Office Action Summary

10/531,379

DETAILED ACTION

FIG 2

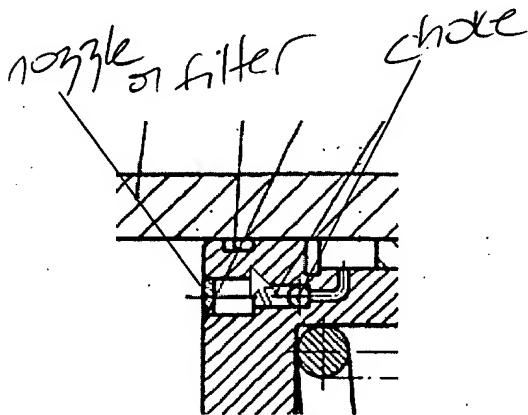
The **Rothe** reference discloses a hydraulic accumulator including piston (1,2) which is moved within the housing in its axial direction and separates the gas side (10) from the fluid side (16). The periphery of the piston having guide elements (5, 6)

which interact with the wall of the accumulator housing and guide (5) also acts as a sealing element. Between sealing element (5) and guide element (6) is a pressure equalization channel (12) discharging on the periphery of the piston, and within the piston is a fluid path to the fluid side. Within the pressure equalization channel is a device (13) that reduces the passage cross section. Upstream of device (13) appears to be a ball valve that would function as a choke device. Likewise, member (13) could function as a nozzle or a porous filter element. **Rothe** does not disclose the structure of the dirt stripper lip. The **Larsson** reference discloses, fig. 1, a hydraulic accumulator piston (2) including guide element (6) adjacent the fluid side and formed with a guide belt with a dirt stripper lip which extends at least approximately to the end of the piston, the guide has a compression ring which sits in an annular groove of the piston periphery with a dirt stripper lip which lengthens its radially outside annular surface on one side in the axial direction and tapers towards its edge. The piston in the peripheral area extends from the fluid-side end to the annular groove has a section of reduced outer diameter over which the stripper lip extends. It would have been obvious to one having ordinary skill in the art at the time the invention was made to modify the **Rothe** reference to include a guide that included a dirt stripper lip, as suggested by **Larsson** in order to provide the piston with a means of pushing debris down from the sides of the piston that could possibly lodge between the piston and the side of the accumulator wall.

stripper lip
